## North Coast Regional Water Quality Control Board

### Inspection Report

**Site:** Joseph Stafslie  
**CIWQS Place ID:** 842383 and 842382  
**Inspection Date:** May 23, 2019

Photo 7 – POD #3 – settling barrel downstream of screened intake

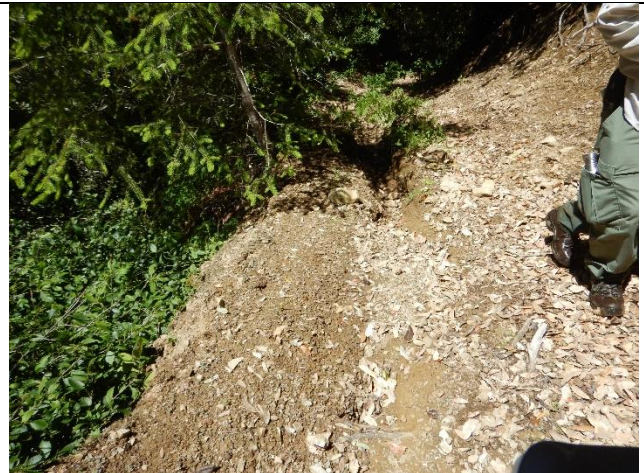
POD #3 in Figure 2 – I observed an intake line with a screen in the pool of a watercourse (photo 6). Directly downstream I observed a settling barrel (photo 7). We discussed in the field moving water diversion infrastructure out of the watercourse to the extent possible.

3. Relocate water diversion infrastructure outside of the active riparian zone to the extent possible
4. Relocate water storage tank to a stable area outside of the required 50-foot riparian setback from the Class III watercourse

Photo 10 – STX 5 – culvert stream crossing

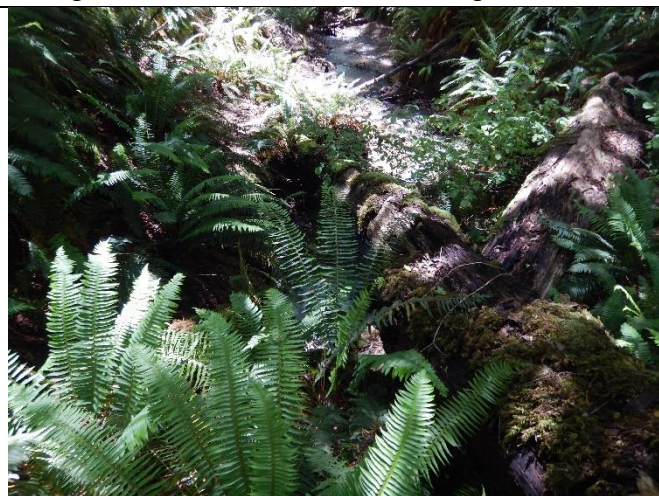
STX 5 in Figure 2 – I observed a culvert stream crossing with a buried outlet (photo 10). Culvert removal and excavation to natural channel gradient is prescribed in the SMP.

1. Retain a licensed professional to develop a workplan and **schedule** to:
  - a. Decommission or replace failing stream crossings
    - i. Update STX 3 recommendation to at least a 48-inch diameter culvert
